Pleasant Beach Village – Fairyland: Conceptual Proposal Review Mtg
Project Manager: David Greetham
Presentation Only

Pavilion/Blue Canary: Design Guidance Meeting
Project Manager: Kelly Tayara

**CITY OF BAINBRIDGE ISLAND
DESIGN REVIEW BOARD – REGULAR MEETING
April 1, 2019**

Date: April 1, 2019
To: Design Review Board
From: Kelly Tayara, Senior Planner
Subject: Design Guidance meeting for the Blue Canary (Pavilion) project

SITE MASTER PLAN - PROPOSED BLA
1" = 100'-0"

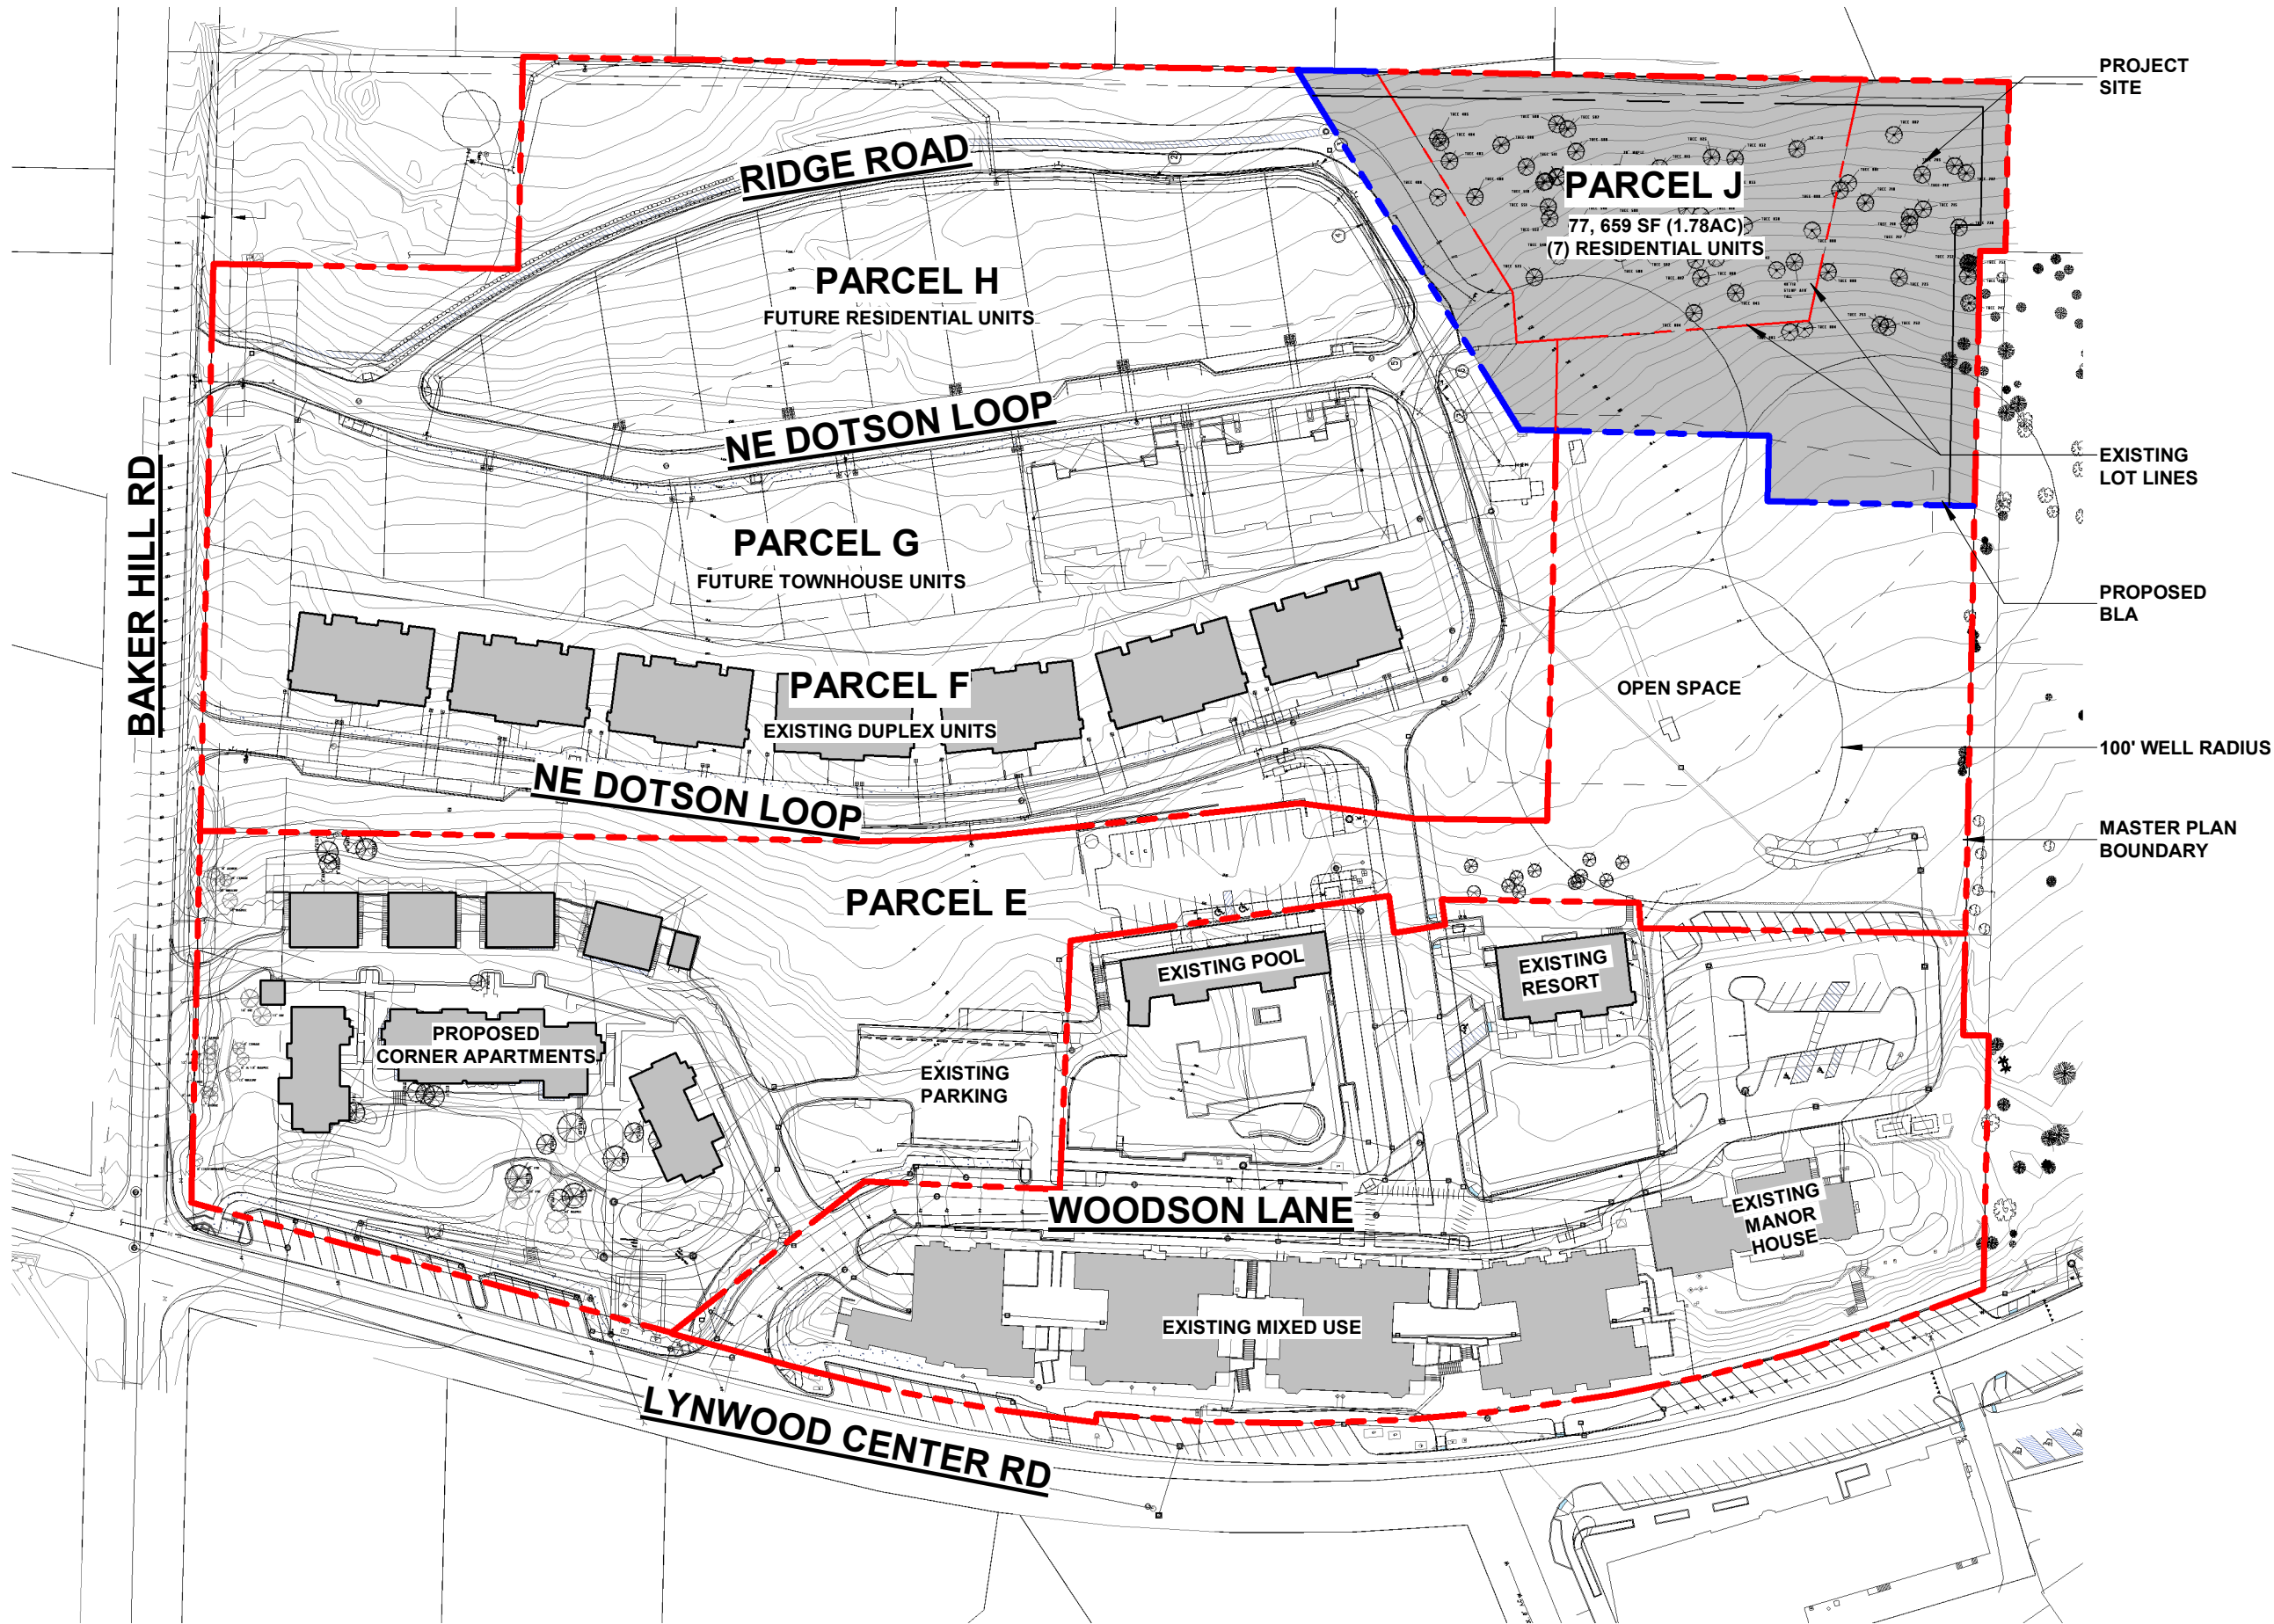
Gary Christensen, Planning Director recapped the requests from the DRB to the applicant as follows:

- The DRB agrees that moving the existing auto repair to another location on the site is supported
- The DRB asked the applicant to come back with a more refined site plan to include: conceptual designs of ingress and egress, how the auto show building will relate to the adjoining properties, design of exterior of buildings, pedestrian access, internal flow, site flow, roads labeled on plans, landscaping (show trees), complete site analysis
- Alternate location of the garage entrance for residence
